RE: Exterior Stairway and Doorway Landings 2018 NCRC Sections R311.3, R311.7.5 and R311.7.6

Ref: Request for Formal Interpretation for Exterior Stairs

Please except this letter as a request for a Formal Interpretation, for the opinion given by Mr. Pak Yip on Sept. 1, 2020 for a set of exterior steps at 3249 Moss Hammock Wynd. 28461.

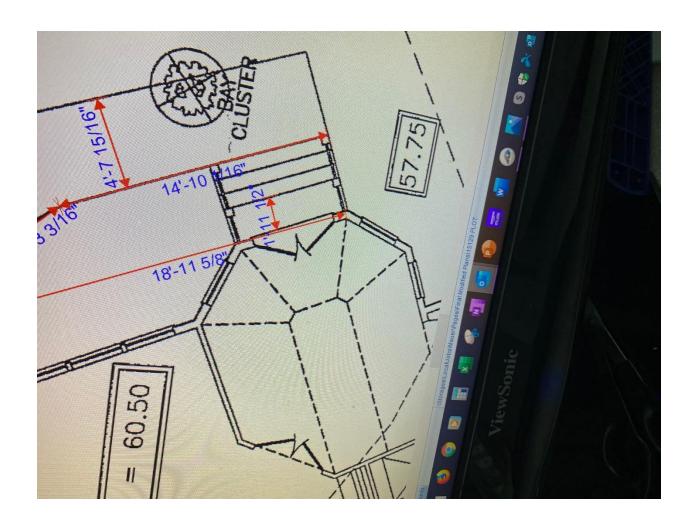
- 1. The stair risers from grade are a consistent 7" except for the last one at the door which is 4 ". Do the stair risers comply with R311.7.5.1 and the code interpretation dated April 9, 2019 for Stair Riser Height Measurement at Thresholds?
- 2. The stair treads are a consistent 1'1" depth from grade. The last one at the door is 1'11". Do the stair treads comply with R311.7.5.2?
- 3. We agree that the top tread is not a landing based on R311.3.2 and its exception.

All of the risers or within tolerance of being 7" excluding the top step, which is 4" to the top of the threshold. With this being a exterior set of steps shouldn't the riser with the 4" rise be at the bottom at the sidewalk per section R311.7.5.1.

R311.7.5.2 states that a tread depth cannot vary more than 3/8" in depth. With the top tread being at 1'-11" and all the others are at a depth of 1'-1", just need a little bit more clarification how you are of the opinion that this is meeting code, with stairs that have no landing.

Section R311.7.6 requires a landing at the top and bottom of all stairways. The exception in R311.7.6 only applies to interior stairs. The situation shown in the photographs provided with the request for formal interpretation does not comply with R311.7.6 because the required 36" running length is not provided and is not exempt by the exception in R311.7.6 because the stair is an exterior stair.

Section R311.3.2 Allows the deletion of a landing for an exterior stairway leading to an exterior door where the door does not swing over the stairway. Use of this exception supersedes Section R311.7.6 because it addresses a more specific situation (ref. R102.1). The exception in R311.3.2 could be applied to the situation shown in the attached photographs, but the top tread exceeds the 3/8" depth differential allowed by Section R311.7.5.2 and 3/8" riser height differential allowed by R311.7.5.1.

The stairway, shown in the photographs of "Attachment A", does not comply with the requirements of the NC Residential Code for either; consistent riser height and tread depth, or for minimum landing size.

- 1. No. Stair risers are allowed a maximum difference in riser height in Section R311.7.5.1 of 3/8".
- 2. No. Stair treads are allowed a maximum difference in riser height in Section R311.7.5.2 of 3/8".
- 3. There was no question stated; so, no response is provided.
